SAFETY EVALUATION REPORT

for the Nichols Ranch In Situ
Recovery Project in Johnson and
Campbell Counties, Wyoming
Materials License No. SUA-1597

Docket No. 040-09067
URANERZ ENERGY CORPORATION

U.S. Nuclear Regulatory Commission

Figure 2.4.1-1 Nichols Ranch Unit and Hank Unit drainage areas

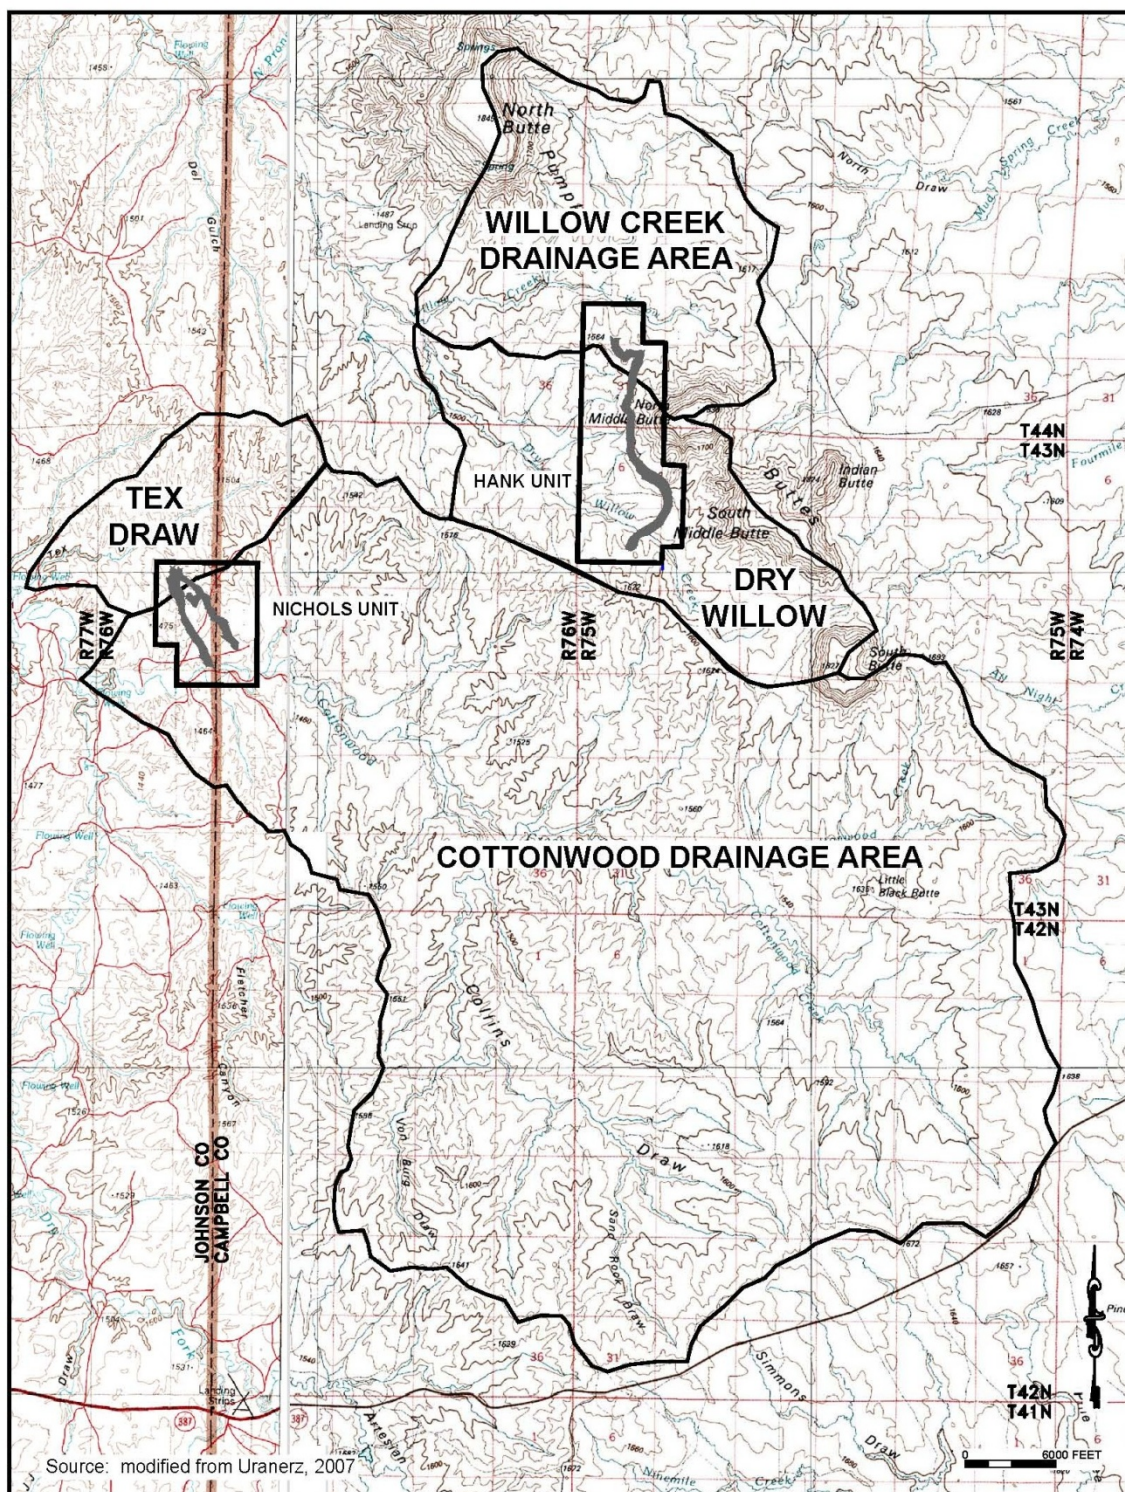
The applicant described the surface water hydrology for the proposed Nichols Ranch Unit. The majority of the Nichols Ranch Unit license area lies within the Cottonwood Creek drainage, which covers 208 km² (80.2 mi²) (SER Figure 2.4.1-1). Cottonwood Creek is a tributary to the Dry Fork of the Powder River and flows from east to west through the southern portion of the license area and enters the Dry Fork about 0.81 km (0.5 mi) downstream of the project area. The northwestern corner of the license area lies within the Tex Draw drainage, which occupies 13.5 km² (5.2 mi²). Tex Draw flows from the northeast to the southwest, north of the license area. Tex Draw is also a tributary to the Dry Fork of the Powder River and enters Dry Fork about 3.2 km (2.0 mi) downstream of the license area. Powder River is a tributary of the Yellowstone River (Uranerz, 2007).

The Hank Unit lies within the Dry Willow and Dry Willow Creek drainages, as shown in SER Figure 2.4.1-1. The Dry Willow drainage occupies 31.6 km² (12.2 mi²) and discharges to Dry Willow Creek, which flows from the southeast to northwest, traversing the southern portion of the license area. It enters Willow Creek approximately 3.2 km (2 mi) west of the license area. The northern portion of the Hank Unit lies within the Willow Creek drainage which covers 34.2 km² (13.2 mi²). It drains directly into Willow Creek, which flows from east to west through the northern portion of the license area. Willow Creek is a tributary of the Powder River and enters the Powder River approximately 26 km (16 mi) downstream of the Hank Unit (Uranerz, 2007).

Figure 2.4.2-1 Potentiometric surface in the Nichols Ranch Unit “A sand” aquifer in 2008 (modified from application Figure D6-5)

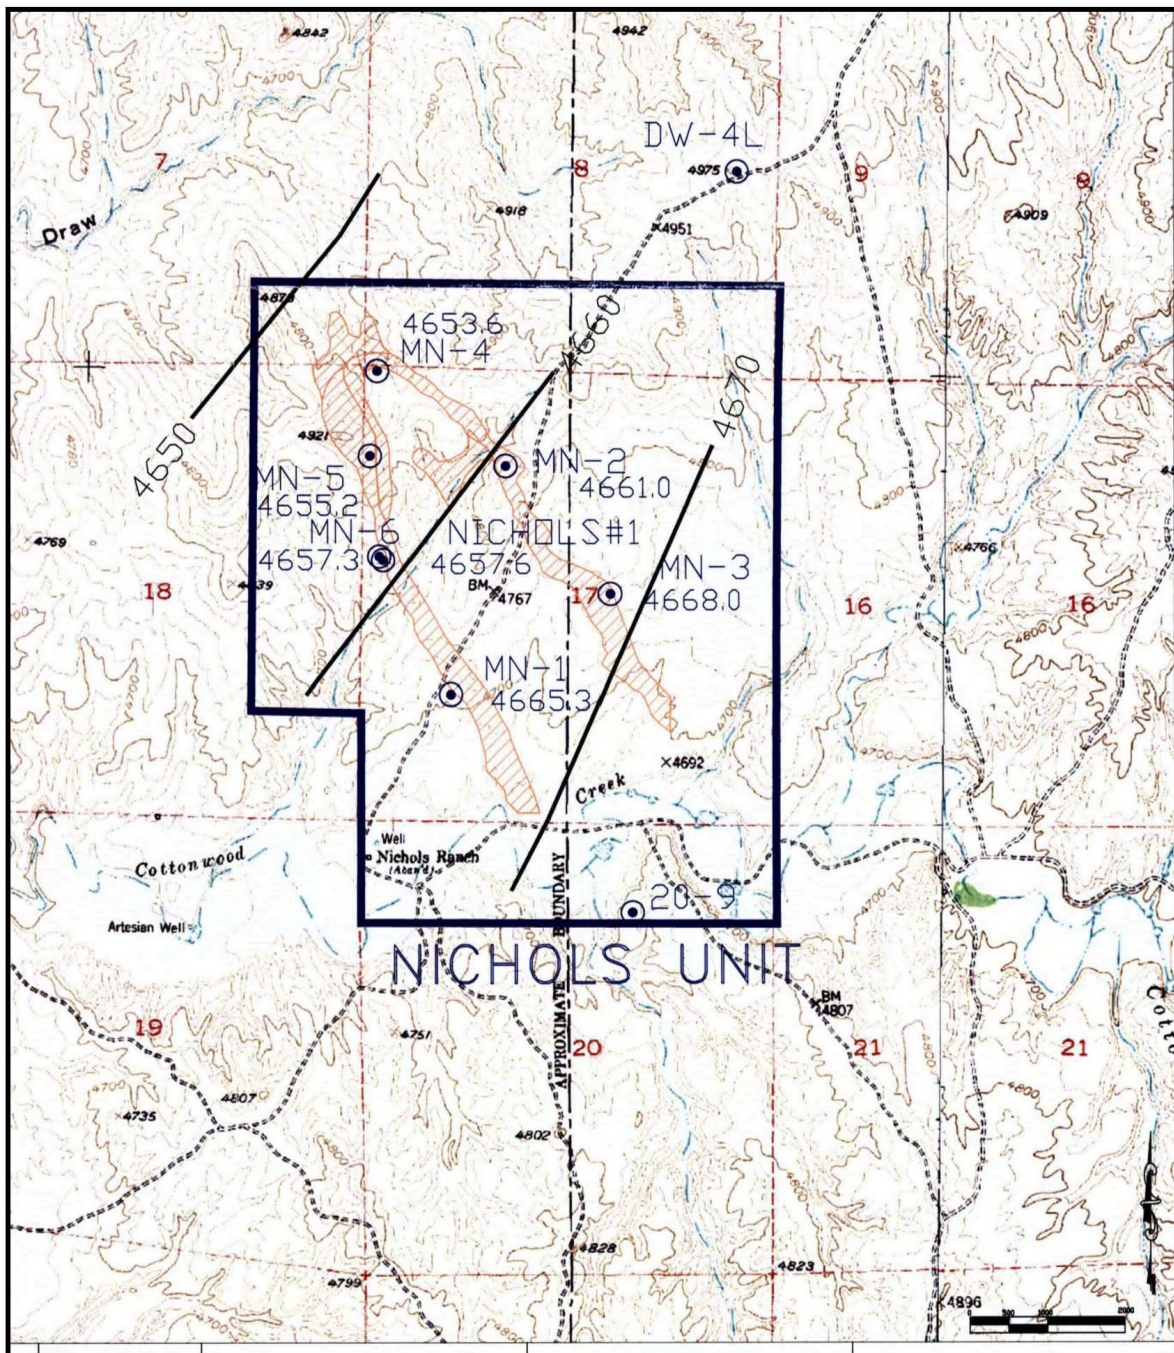
The applicant reported that below the "B sand" aquifer is the "A sand" aquifer, which is the ore zone in the Nichols Ranch Unit license area. The applicant used seven wells (MN-1, MN-2, MN-3, MN-4, MN-5, MN-6, and Nichols 1), shown in SER Figure 2.4.2-1, to measure water levels in the "A sand." Water levels in the "A sand" demonstrate that the aquifer is a confined (saturated) aquifer, with a potentiometric surface rising approximately 122 m (400 ft) above the top of the sand. Based on the potentiometric contours, the applicant reported the ground water flow direction in the "A sand" is to the northwest with a gradient of 0.0033. Application Figures D6D.1-1 and D6D1-2 show the variation in water level over time for these wells. The staff reviewed these figures, which indicate that the water levels were relatively steady over the period from late 2006 to the beginning of 2010.

Figure 2.4.2-2 Water wells within a 0.81-km (0.5-mi) boundary of the Nichols Ranch Unit (modified from application Figure 2-17)

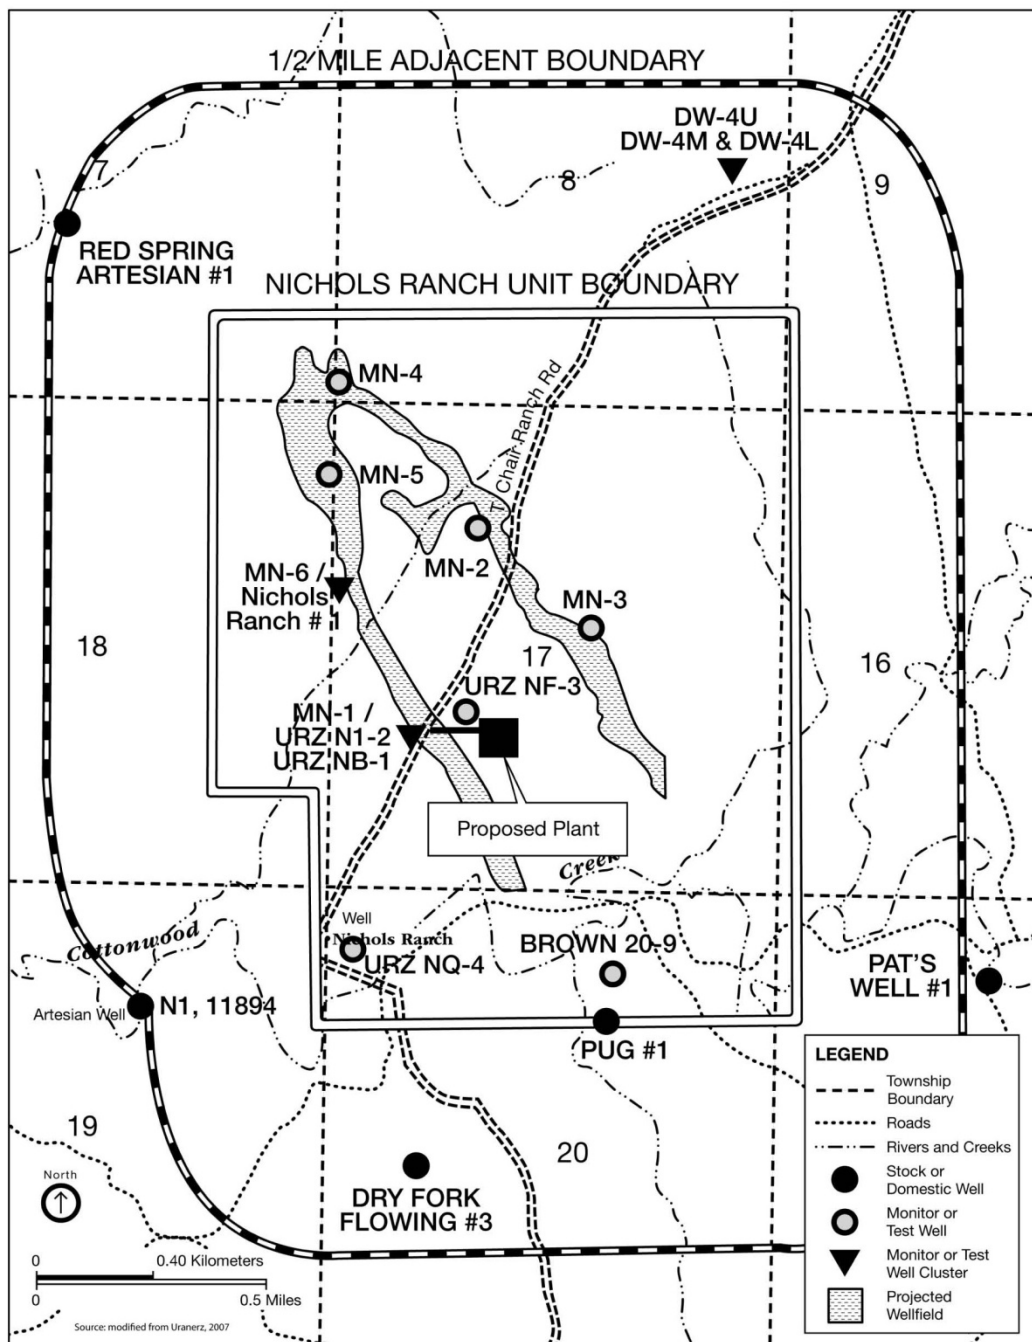
The applicant provided a map of water wells within 0.81 km (0.5 mi) of the Nichols Ranch Unit license area, as shown in SER Figure 2.4.2-2. Application Table D6-2 provides completion data for these wells, including the aquifers in which they are screened. Based on a search of the water permit database of the Wyoming State Engineers Office for this area, the staff found that the majority of wells are stock wells or monitoring wells. No water wells permitted for domestic use are located within this 0.81-km (0.5-mi) boundary. The applicant also presented a map of all permitted wells within a 4.8-km (3-mi) radius in application Exhibit D6-1 and the associated ground water permits in application Table D6G.1-2. According to the table, the majority of wells are stock or monitoring wells. Two domestic wells, Doughstick #3 and Garden Well, are located approximately 3.2 km (2 mi) southeast of the license area. One other domestic well, Dry Fork #1, associated with a residence at Dry Fork Ranch, is located approximately 1.6 km (1 mi) to the west of the license boundary. The depth of this well is unknown.

Figure 2.4.2-4 Water wells within a 1/2-mile boundary of the Hank Unit

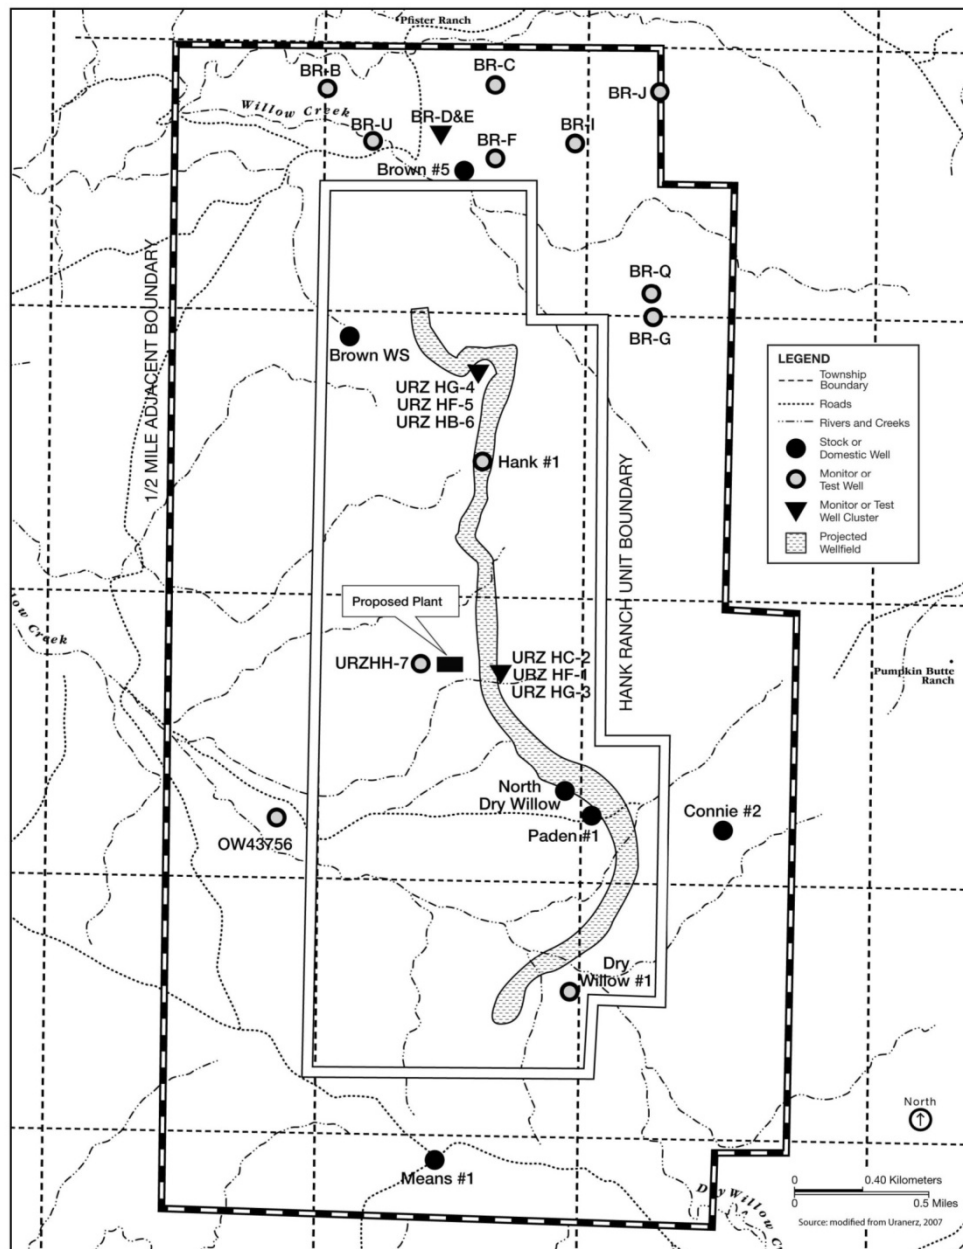
The applicant provided a map of water wells within 0.81 m (0.5 mi) of the Hank Unit license area, as shown in SER Figure 2.4.2-4. Application Table D6-3 provides completion data for these wells, including the aquifers in which they are screened. Based on a search of the database of ground water permits and well descriptions for this area in the Wyoming State Engineers Office, the staff found that the majority of wells are stock wells or monitoring wells. No water wells permitted for domestic use are located in this 0.81-km (0.5-mi) boundary area. The applicant also presented a map of all permitted wells within a 4.8-km (3-mi) radius in application Exhibit D6-2 and the associated ground water permits in application Table D6G.2-2. According to this table, the majority of wells are stock or monitoring wells.
